Accessibility Survey

City of Downey Country Club Drive - Old River School Road to End

Date of Inspection 7/6/2017

Disability Access Consultants

Top Landing

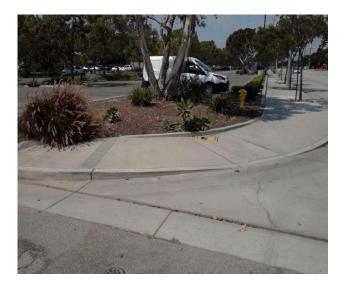
The slope at the top landing is greater than allowed.

On-Site Finding 3.80 percent

Provide a top landing surface that does not exceed the maximum slope and cross slope. Provide a sufficient maneuvering clearance that does not accumulate water.

Recommendation Up to 2.08 percent

Curb Ramp : No Detectable Warnings

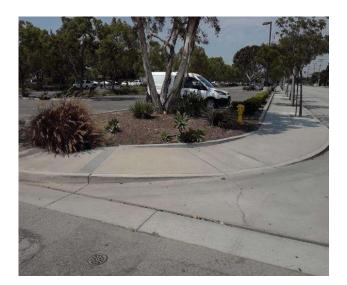
The curb ramp does not provide a detectable warning surface which includes truncated domes.

On-Site Finding Not Found

Provide compliant detectable warnings to surface.

Bottom Landing

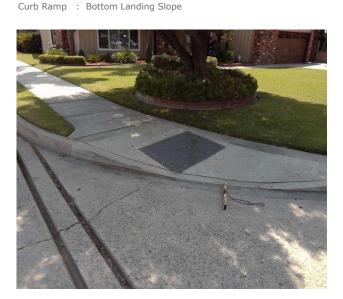
The bottom landing of the curb ramp is on the street, and the slope of the bottom landing is not compliant.

On-Site Finding 6.50 percent

Ensure the bottom landing slope is compliant and provides a smooth transition.

Recommendation Up to 5.00 percent
